# Access Compliance Report

## Public Rights-of-Way

### (Curb Ramps)

Intersection ID: 17494	Main Street: MONROE_RD	Cross Street: FOREST_WAY_DR	Location: SW
ADA ID: A759E529EA0A	Ramp Type: PerpDiag	Initial Pass/Fail: Fail	Overall Compliance: No
		Severity Score: 25

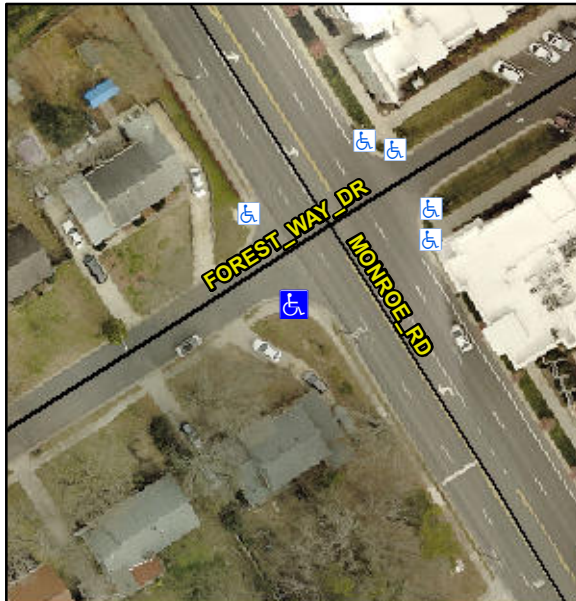
**R304.5.3**

Compliance	Description	Data	Compliance	Description	Data
N/A	Ramp Length (in)	69.0	Yes	Ramp Slope (%)	5.5
Yes	Ramp Width (in)	59.0	No	Ramp XSlope (%)	7.3
N/A	Flare Type LT	N/A	N/A	Flare Type RT	N/A
N/A	Flare Slope LT (%)	N/A	N/A	Flare Slope RT (%)	N/A
N/A	Flare Traversable LT?	N/A	N/A	Flare Traversable RT?	N/A
N/A	Landing Length (in)	N/A	N/A	DWS Provided?	N/A
N/A	Landing Width (in)	N/A	N/A	DWS Contrast?	N/A
N/A	Landing Slope (%)	N/A	N/A	DWS Length (in)	N/A
N/A	Landing X Slope (%)	N/A	N/A	DWS Full Width?	N/A
N/A	Landing Curb? (Y/N)	N/A	N/A	DWS Offset (in)	N/A
N/A	Shared Landing?	N/A			
N/A	Gutter Ponding?	N/A	N/A	Gutter Slope (%)	N/A
N/A	Gutter Lip Ht (in)	N/A	N/A	Gutter X Slope (%)	N/A
N/A	Painted X Walk1?	No	N/A	Painted X Walk2?	No
	X Walk 1 Direction	To E		X Walk 2 Direction	To N
N/A	X Walk 1 Width (in)	N/A	N/A	X Walk 2 Width (in)	N/A
	X Walk 1 Slope (%)	8.3		X Walk 2 Slope (%)	2.7
	X Walk 1 X Slope (%)	0.6		X Walk 2 X Slope (%)	9.0

N/A	Ramp inside XWalk1?	N/A	N/A	Ramp inside XWalk2?	N/A
	Road Slope (%)	4.2	N/A	Clear Space?	N/A
	Road X Slope (%)	7.3	N/A	Clear Space to XWalk (in)	N/A
N/A	Any Obstructions?	N/A	N/A	Storm Grate/Utility Hazard?	N/A
	Obstruction Type			Storm Grate/Utility Type	
		N/A			N/A
		Yes		Surface Condition? (G/P)	Good

**Remove & Replace Curb Ramp With Two New Directional Ramps or Equivalent.**
